Enclosed is the response to the Environmental Protection Agency's List of Modifications to the response on the Notice of Deficiency on the RFI Work Plan for Operable Unit 1111. A signed certification statement regarding this response is also enclosed.

Response to the Environmental Protection Agency's (EPA) Draft
List of Modifications on the Notice of Deficiency (NOD) Response
for Operable Unit (OU) 1111

**LANL Response to Draft List of Deficiencies
Operable Unit 1111**

Index Showing Soil Sampling Locations

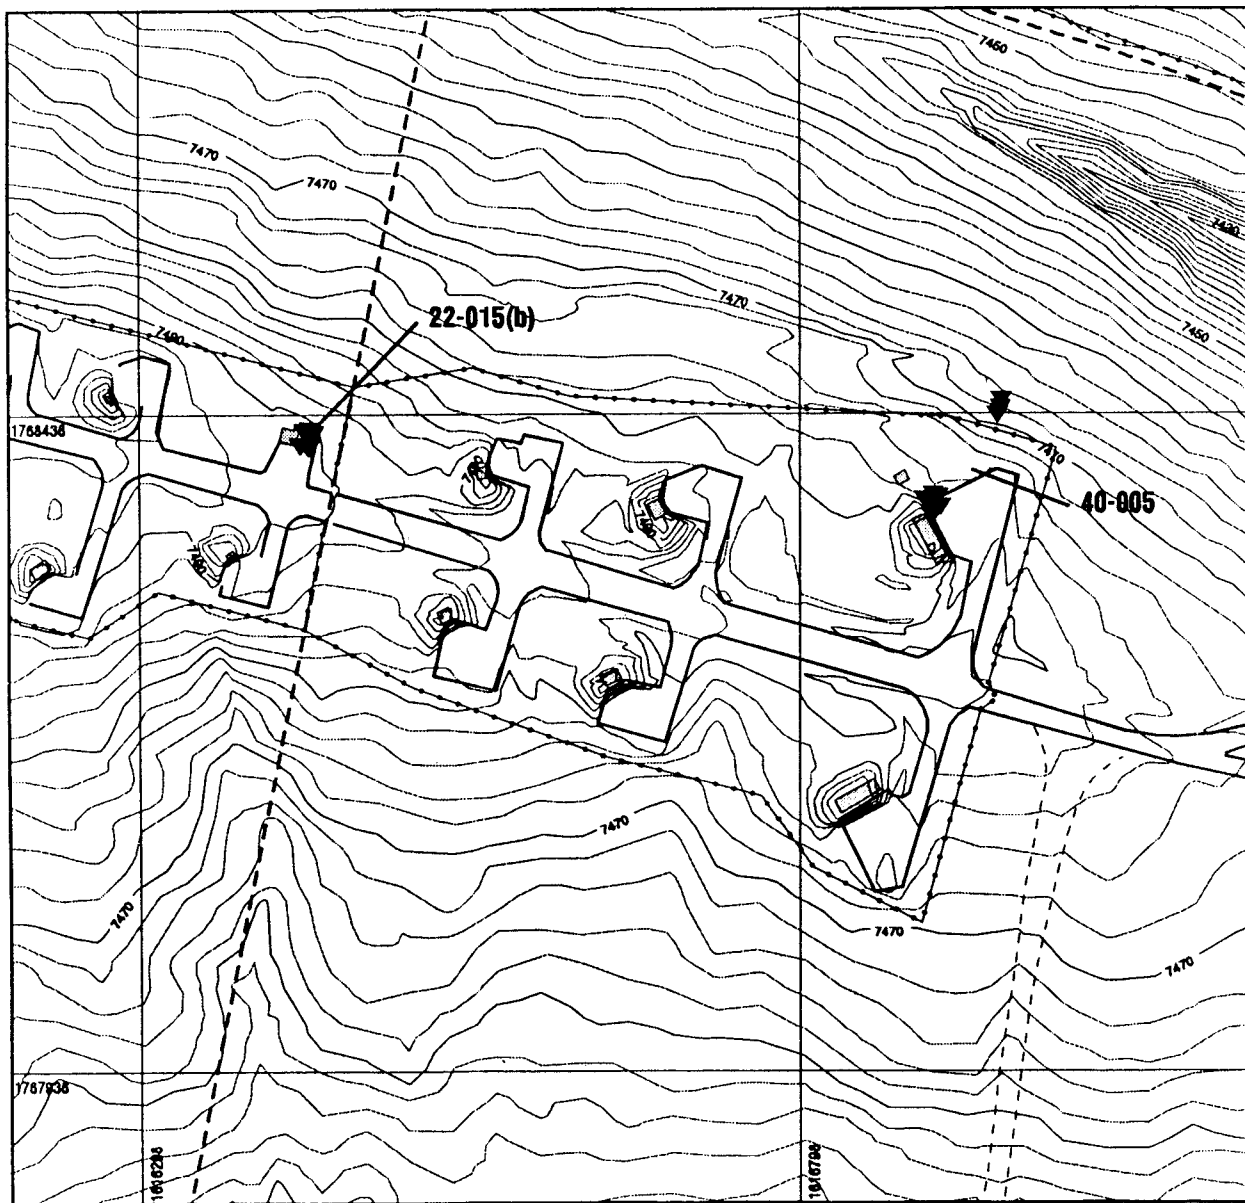
4. *Figures provided in the August 1, 1994 additional response do not indicate SWMU numbers. Figures should be revised and resubmitted.*

Revised figures are enclosed with this response.

Surface Soil Sampling Locations for SWMUs 22-015(b) and 40-005

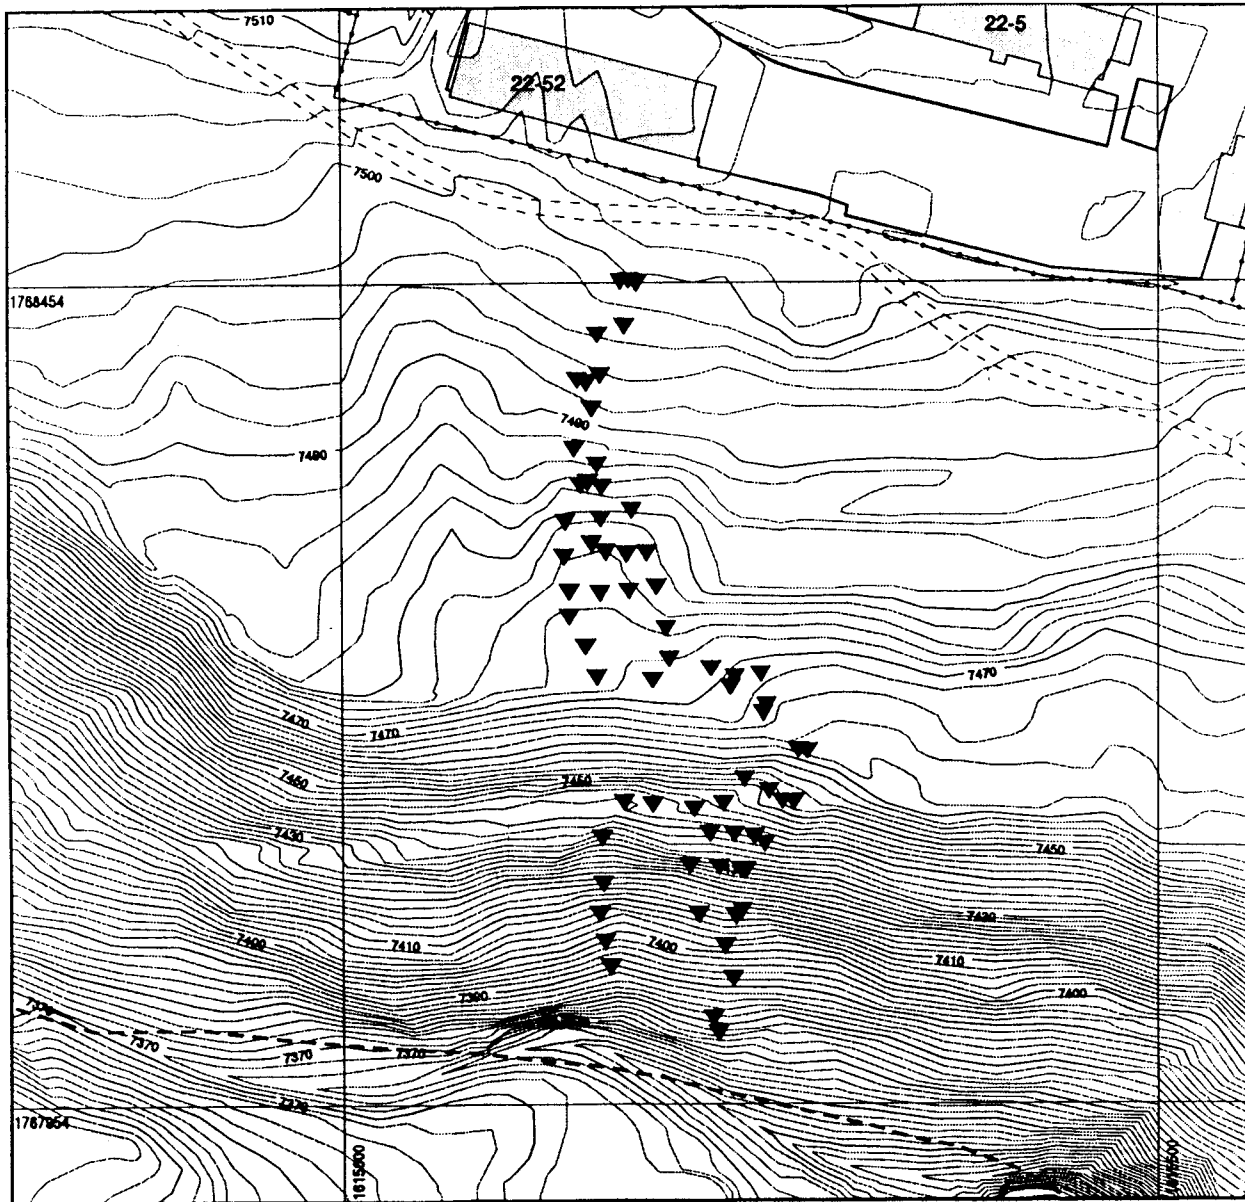
6. *Response 7.e.ii, Table 5-8, p. 5-39 - The sludges for sumps 22-015(b) and 22-015(d) should be analyzed for volatile organics (SW 8240).*

We concur and will analyze those sludges for volatile organics.
